January 14, 2021

RE: Response to Notice of Preparation-Berggruen Institute Project at 1901 North Sepulveda Boulevard and 2100-2187 North Canyonback Road; EIR No. ENV-2019-4565-EIR

Leighton & Associates Landslide/Slump Map

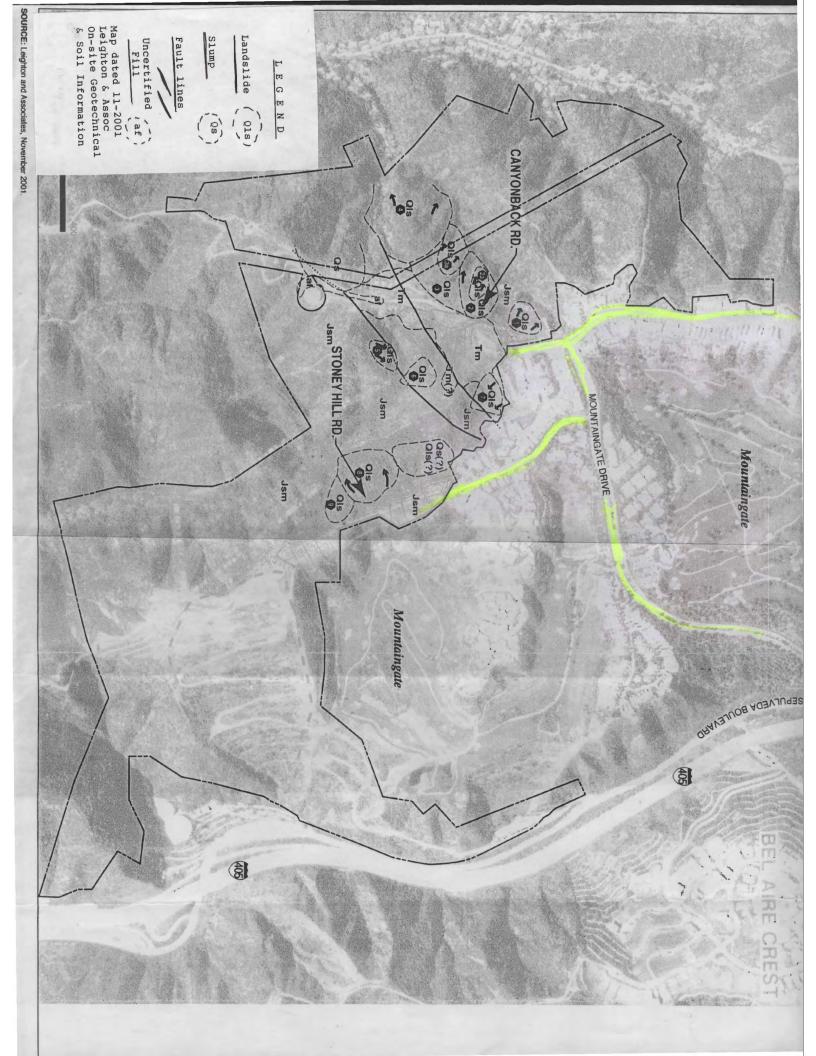
QUESTION: There are nine historic landslides on the property. (See Landslide Map, Exhibit D.) Will any of the Project's water delivery systems or landscape-water be diverted into any landslide- vulnerable areas?

QUESTION: There are nine historic landslides on the property, will these landslides be remediated? If not, will these historic landslides present a danger to this Project?
